# Access Compliance Report

## Public Rights-of-Way

### (Curb Ramps)

Intersection ID: 10014544	Main Street: BROOKSIDE_LN	Cross Street: N/A	Location: NE
ADA ID: E18216E52B8D	Ramp Type: PerpDiag	Initial Pass/Fail: Fail	Overall Compliance: No
			Severity Score: 33.75

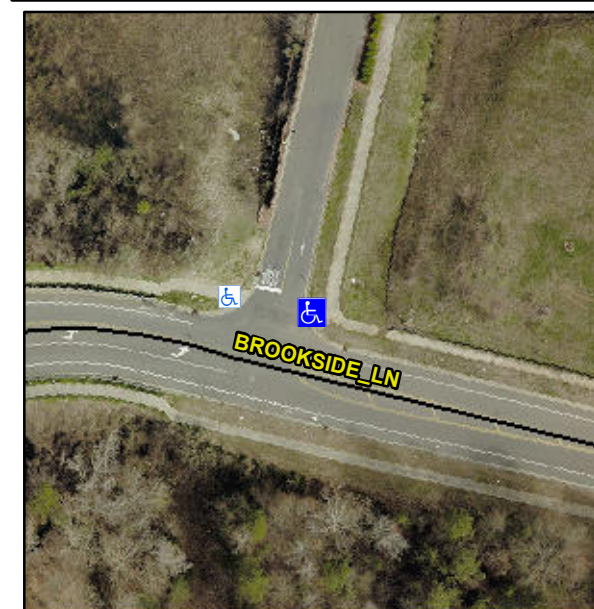
Compliance	Description	Data	Compliance	Description	Data
N/A	Ramp Length (in)	103.5	Yes	Ramp Slope (%)	7.1
No	Ramp Width (in)	40.5	No	Ramp XSlope (%)	7.1
N/A	Flare Type LT	N/A	N/A	Flare Type RT	N/A
N/A	Flare Slope LT (%)	N/A	N/A	Flare Slope RT (%)	N/A
N/A	Flare Traversable LT?	N/A	N/A	Flare Traversable RT?	N/A
N/A	Landing Length (in)	N/A	N/A	DWS Provided?	N/A
N/A	Landing Width (in)	N/A	N/A	DWS Contrast?	N/A
N/A	Landing Slope (%)	N/A	N/A	DWS Length (in)	N/A
N/A	Landing X Slope (%)	N/A	N/A	DWS Full Width?	N/A
N/A	Landing Curb? (Y/N)	N/A	N/A	DWS Offset (in)	N/A
N/A	Shared Landing?	N/A			
N/A	Gutter Ponding?	N/A	N/A	Gutter Slope (%)	N/A
N/A	Gutter Lip Ht (in)	N/A	N/A	Gutter X Slope (%)	N/A
N/A	Painted X Walk1?	No	N/A	Painted X Walk2?	No
	X Walk 1 Direction	To S		X Walk 2 Direction	To W
N/A	X Walk 1 Width (in)	N/A	N/A	X Walk 2 Width (in)	N/A
	X Walk 1 Slope (%)	3.4		X Walk 2 Slope (%)	6.5
	X Walk 1 X Slope (%)	6.5		X Walk 2 X Slope (%)	2.7

**Remove & Replace Curb Ramp With Two New Directional Ramps or Equivalent.**

**R304.5.1, R304.5.3**
